Corrections to

**Information technology—
Telecommunications and information exchange between systems—
Local and metropolitan area networks—Specific requirements—**

Part 3: Carrier sense multiple access with collision detection (CSMA/CD) access method and physical layer specifications

Correction Sheet
Issued 1 May 2001

**Figure 2-2—Service specification primitive relationships
(optional MAC control sublayer implemented)**

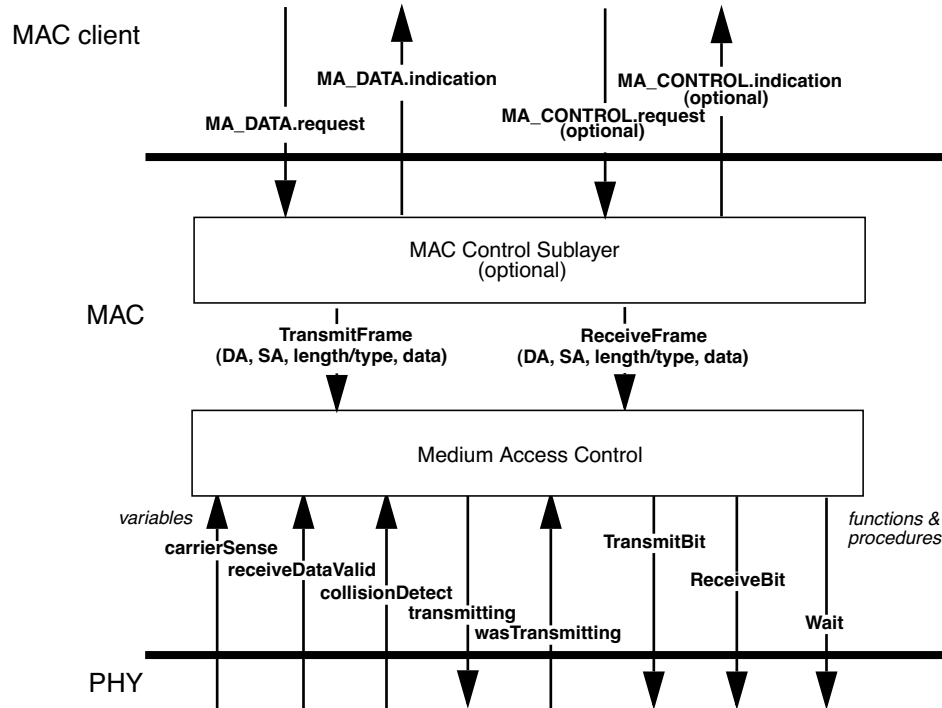
Page 34: Figure 2-2.

Replace Figure 2-2 with the following figure.

NOTE—The deletion of the wasTransmitting arrow, restored by the above, has been proposed by an IEEE P802.3 Revision Request, (URL - http://www.ieee802.org/3/maint/requests/maint_1021.pdf) which is currently being balloted as part of IEEE P802.3ag Maintenance Ballot #6. This was published in IEEE Std 802.3, 2000 Edition in error.
